**PARK CITY MUNICIPAL CORPORATION
HISTORIC PRESERVATION BOARD
CITY COUNCIL CHAMBERS
December 5, 2017**

424 Woodside Avenue – HDDR Review for Reorientation - Reorientation (rotation) of a “Significant” Structure towards Woodside Avenue and lifting of the Historic Structure 7 feet 7 ¾ inches. The primary façade of the Significant Structure is currently oriented towards Main Street and the applicant is proposing to rotate the structure 180 degrees so that the primary façade is oriented towards Woodside Avenue. Upon reorientation, the Historic Structure would be lifted 7 feet 7 ¾ inches.

Author: Hannah M. Tyler, Planner
Subject: Reorientation Review
Address: 424 Woodside Avenue
Project Number: PL-16-03379
Date: December 5, 2017
Type of Item: Administrative – Reorientation (Rotation)

Figure 2b: Proposed Reorientation – West Façade

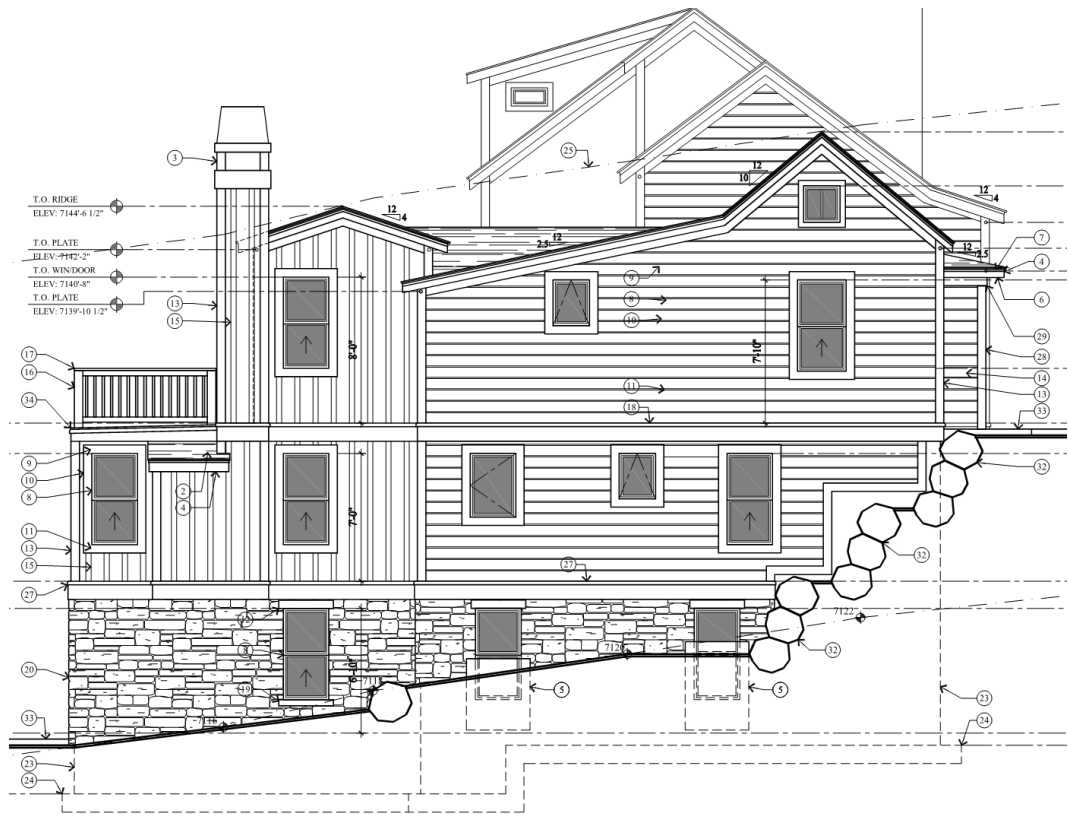
If the reorientation and proposed design is approved, the house will no longer read as a single-story structure and will appear larger and out-of-scale with its historic form. The proposed design, visible in Figure 2b articulates the scale and multi-level appearance of the proposed design once the Historic Structure is lifted and rotated.

Figure 12: Existing Conditions of the North Elevation – Approximate Measurement Of Main Floor Level Above Existing Grade.

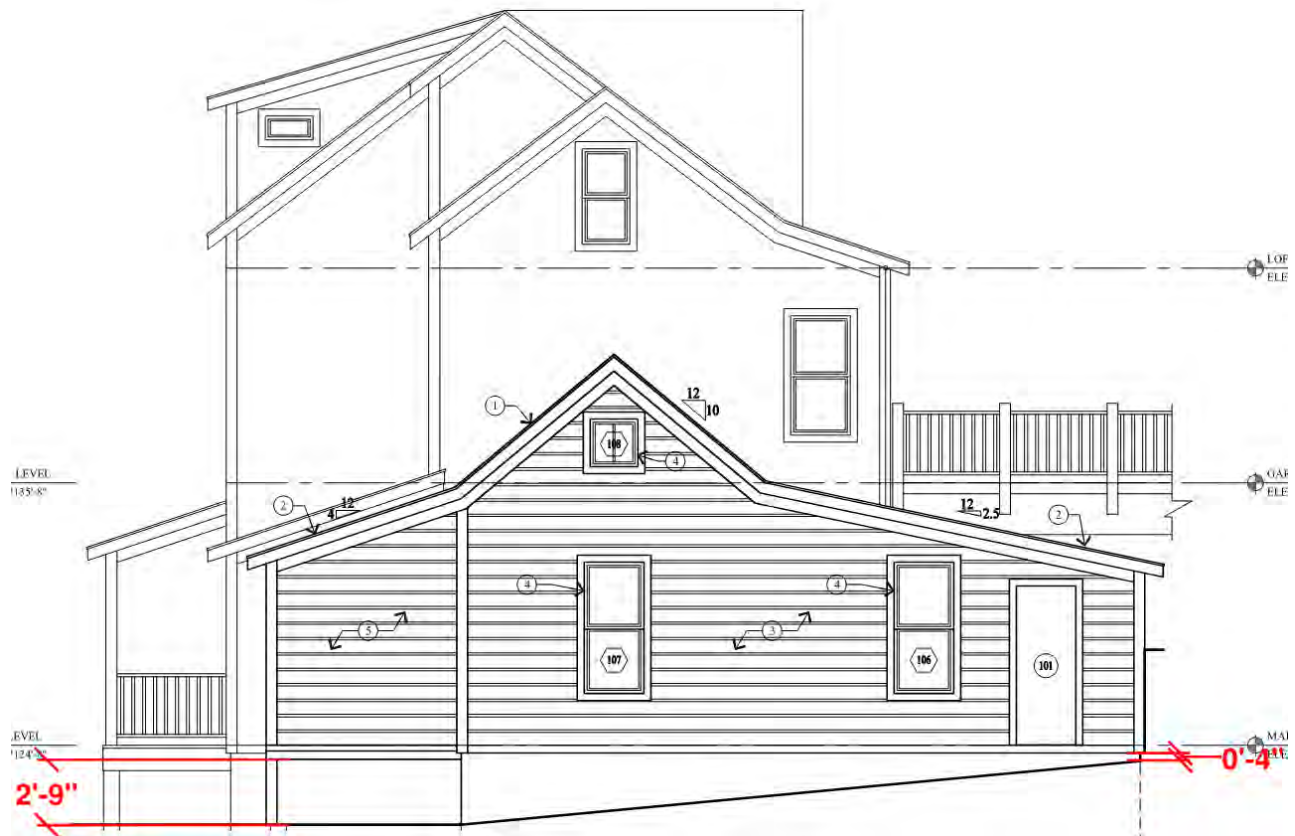
The Historic Structure's main floor level will go from being between approximately 4 inches and 2 feet 9 inches above existing grade to between approximately 1 foot and 13 feet 2 inches above Final Grade. Staff has identified this change in Figure 12 and 13.

Staff finds that the combination of reorientation and lifting (beyond what is specified in the Design Guidelines) results in the loss of Historic scale

Figure 14a: Existing Site Plan identifying the presumed remaining Historic Materials (in green). Drawing has been rotated, north is up and Woodside Avenue is to the left.

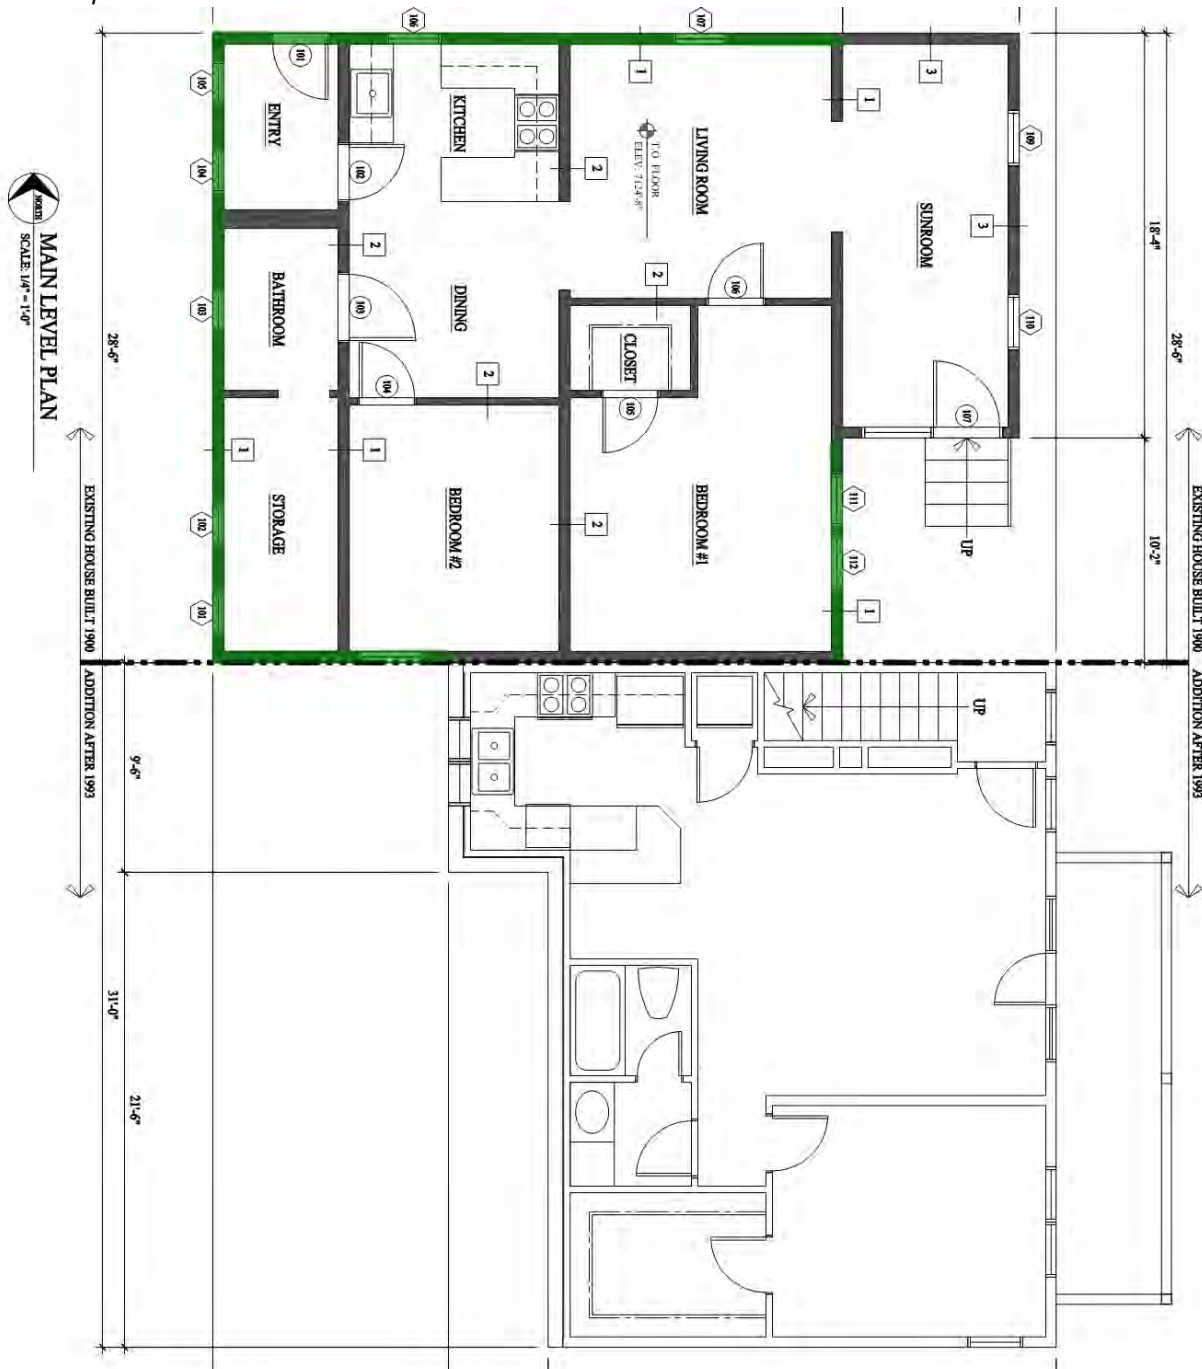
If the Historic Structure is reoriented towards Woodside Avenue, the Historic Structure will lose its remaining historic material additions (see Exhibits F and G for the applicant’s Historic Preservation Plan and Physical Conditions Report). Over the years, the Historic Structure has lost Historic material through remodel. Because of this, it is essential to retain what Historic material is remaining; otherwise this would be a Historic site with little to no Historic material remaining. While the LMC does allow for

reconstruction – meaning sites built with non-historic materials to match the historic materials – this proposal does not meet the criteria for Reconstruction. Staff has not determined unique conditions to warrant further loss of the remaining Historic materials and find that this aspect of Essential Historic Form will be lost if the Historic Structure is reoriented. Figure 14a and 14b articulates the approximate existing Historic material of the existing Historic Structure and the impact on Historic material after reorientation.
